Access Compliance Report Public Rights-of-Way (RR Crossings)

Intersection ID: 7375	Main Street: N_TRYON_ST	Location: N/A
ADA ID: 16946EF3DB35	Overall Compliance: No	Severity Score: 0.0
Codes/Mitigation Info/Possible Solution		Field Measurements/Component Compliance

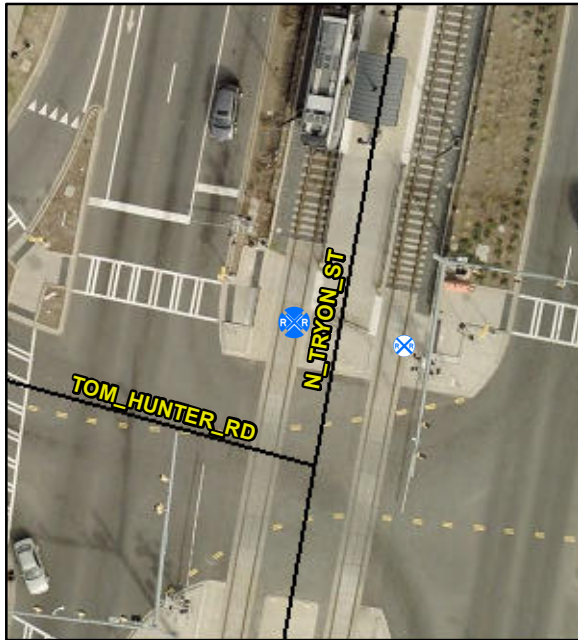
Compliance	Description	Data
Yes	DWS Provided?	Yes
Yes	DWS Contrast?	Yes
Yes	DWS Width (in)	Yes
Yes	DWS Length (in)	24.0
Yes	DWS Offset (in)	83.0
No	Pedestrian Gate?	No
N/A	DWS Outside Gate?	No
N/A	Rail Type?	LightRail
No	Flangeway Gap (in)	2.625
Yes	Sidewalk Width (in)	116.0

**Remove & Replace Detectable
Warning System. Provide Pedestrian
Gate. Remove & Replace Walking
Surface Adjacent to Rail.**
